Catherine fields Community Road Safety Audit/ Review

Report

This review is in relation to the proposed planning for a school to be located at the midpoint along Catherine fields road.

The paper is part of a submission to the Council to raise community concerns over the proposal.

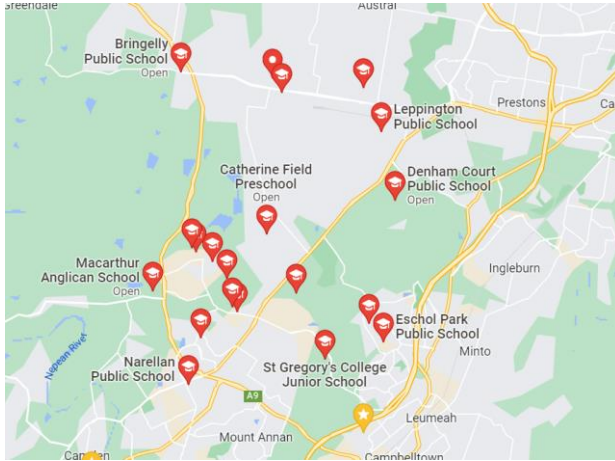
These are explored in detail below, however the key identified risks are in relation to end of queue incidents relative to the current proposed site location. There is a short distance curve that will impact south-east travelling motorists and increase the risk of incidents in this location. This is compounded by the behaviours and current signposted limited of 80km/p/h which would require significant road design features to be in place to create a safe environment.

There is also poor line of sight at the major corridor interchange between Catherine fields road and Deepfields road. Any further capacity at this intersection without a full dual carriageway upgrade would see a significant risk for turning motorists. This is for those turning right into Catherine fields road with a small turn lane and therefore a queueing issue for thoroughfare motorists (and end of queue incident risk) but will also be difficult for motorist turning left or right from Catherine fields road into Deepfields road. The lack of line of sight to the right when turning left, and the obstruction of traffic from the left to enable turning right, are both going to impact safe outcomes.

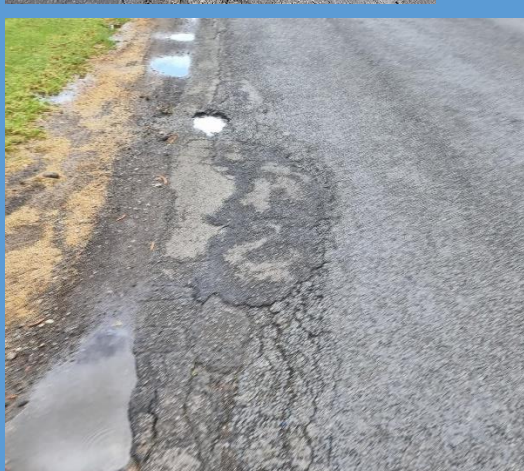
Risk: Road conditions

There are poor road conditions on all corridors, including potholes and very poorly constructed temporary hot and cold mix patches across a large percentage of the corridor. These features create hazards for motorists and increase the risk of traffic incidents, vehicle wear and tear and present significant challenges relating to interface risks with pedestrians and motorists.

Photo 1- 10cm depression, divet in road surface. Indicative of type of condition over 60% of the road/ corridor

Photo 2- Example of potholes and poor line delineation of the road surface. The pothole is 15cm by 8 cm, and 3 cm deep. This is indicative of potholes across the corridor

Photo 3- Example of patchwork hot/cold mix applied to surface. This creates a 24-hour fix, but otherwise presents a hazard and the mix mis forms due to heavy wear and tear. This picture is also indicative of road flooding in weather events.

Photo 4- Example of potholes, wear and tear and poor line marking and edge protections for motorists
